Telecommunications and Coastal Permits for AT&T Wireless Telecommunication Sites

Response to Comments and Questions Raised by the City Council and the Public at the Meeting of August 15, 2017 and in Subsequent Correspondence

Figure 1 - Figure 1 shows the location of these 16 proposed nodes relative to existing AT&T antenna facilities within the City as well as commercially-zoned properties:

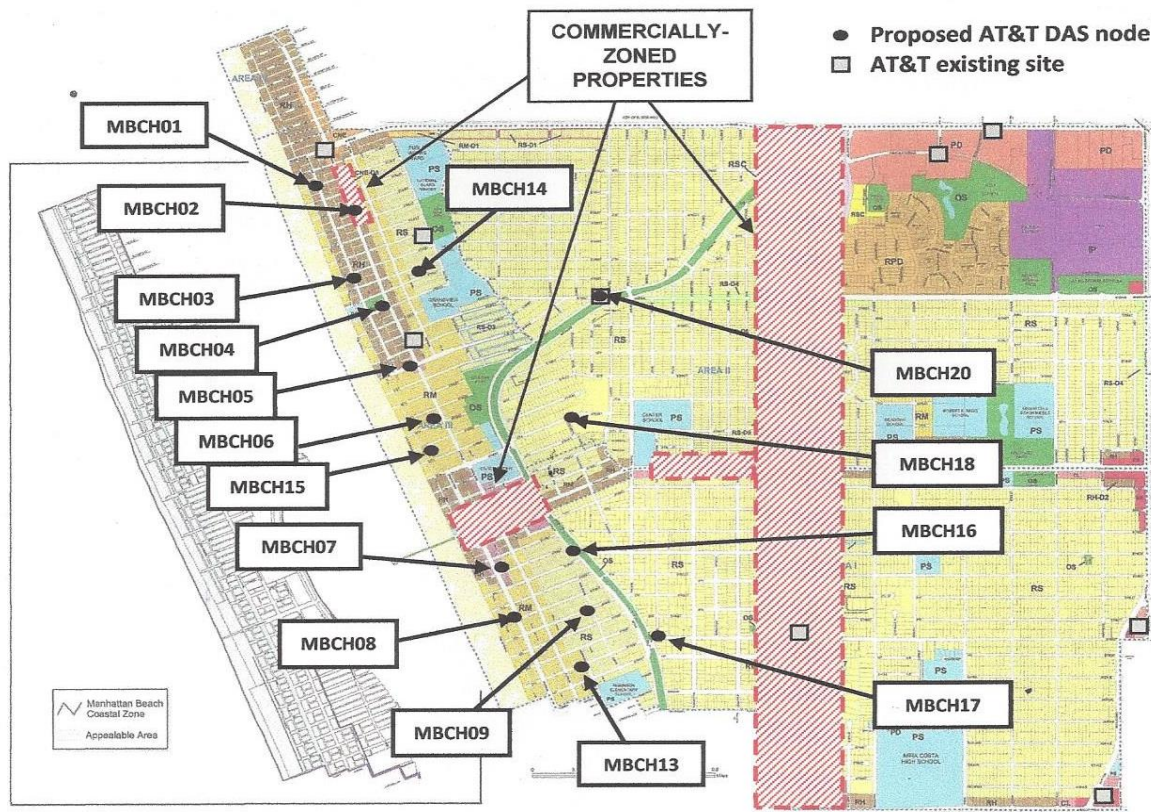
1. Explain why/how the locations for sites have been chosen.

As can be seen in Figure 1 above, the existing AT&T Mobility macro antenna facilities are too far to the east to be modified to serve the beach area and the commercially-zoned properties along Sepulveda Boulevard are also too far to the east to be useful as antenna facilities. It is for this reason that the small-scaled DAS project was selected as a good solution to provide service to this critical beach area of the City. Figure 2 shows the existing AT&T coverage and Figure 3 shows the proposed AT&T coverage under the project.

Figure 4 – Existing Wireless Antenna facilities within the City of Manhattan Beach

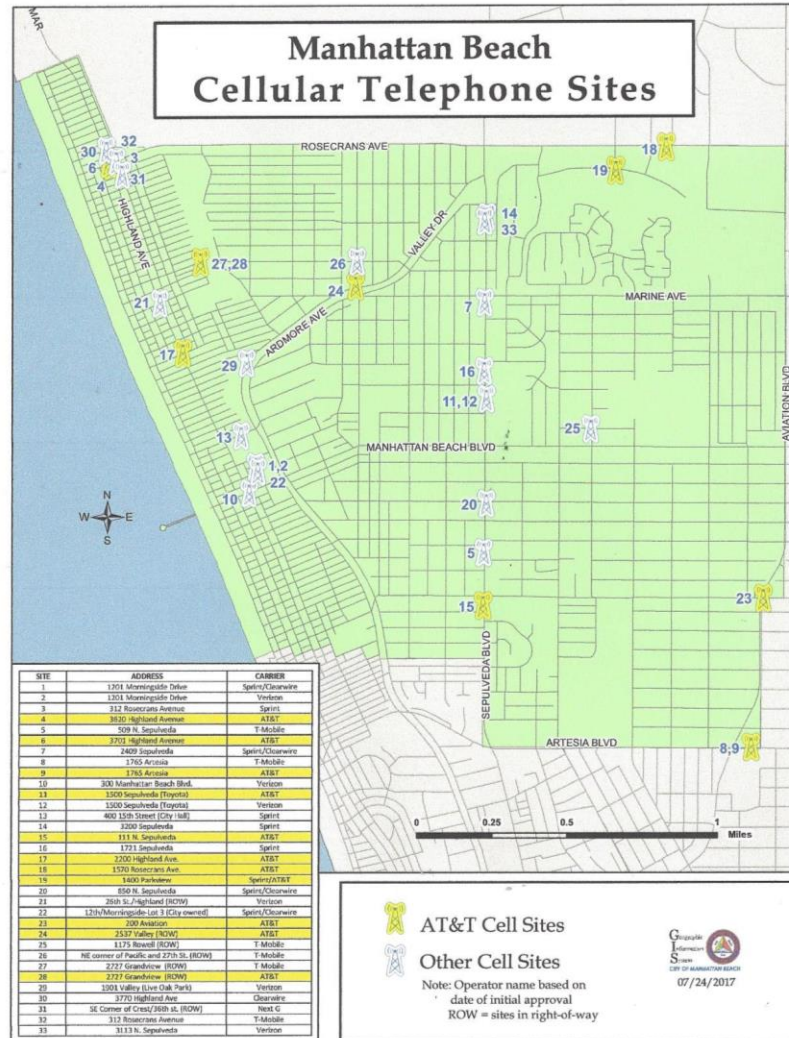
3) Where are the other carriers' telecommunication sites located and can they be collocated?

Figure 4 below shows the locations of the currently operating wireless facilities within the City and their type (building, tower, etc.) as provided by City Planning staff. The target service areas for the proposed projects and the commercially-zoned properties within the City are shown in Figure 5 below to illustrate the proximity of the existing antenna facilities to the intended service area.

Figure 5 - Map of beach target service area and nearest commercial districts with existing cell sites to show how they will not work to cover the service area

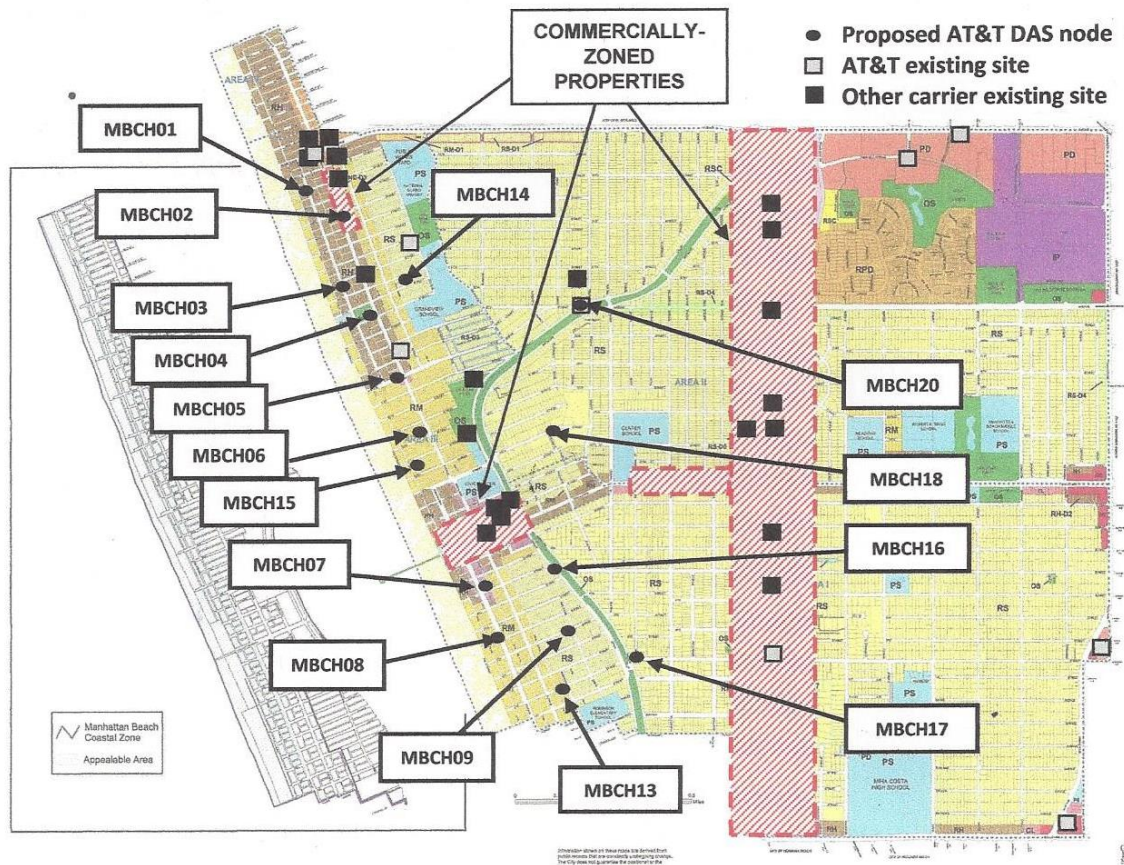
7. Can antennas be attached to existing commercial buildings?

The lack of adequate AT&T signal coverage in the City's beach district generally west of Valley Drive was previously documented above. As shown in Figure 5, the beach area to be served is entirely residential and the closest commercial buildings are 0.75 to 1.25 miles away inland. Also, as previously noted, the target area, the beach portion of the City, has a varied, hilly topography that cannot be served by existing macro antenna facilities within the City.

The commercially-zoned properties are too far inland and the signals from existing macro antenna facilities within the City cannot be extended or changed to serve the target area.

Specifically, as shown in Figure 5 above, the beach area to be served is entirely residential and the closest commercial buildings are 0.75 to 1.25 miles away inland. As previously noted, the target area, the beach portion of the City, has a varied, hilly topography. The commercially-zoned properties are too far inland to provide service. Antennae would need to be placed 40-50 feet or higher above the existing commercial buildings in order to clear the surrounding buildings and hilly topography. Installations at such heights are not the least intrusive means to achieve coverage.
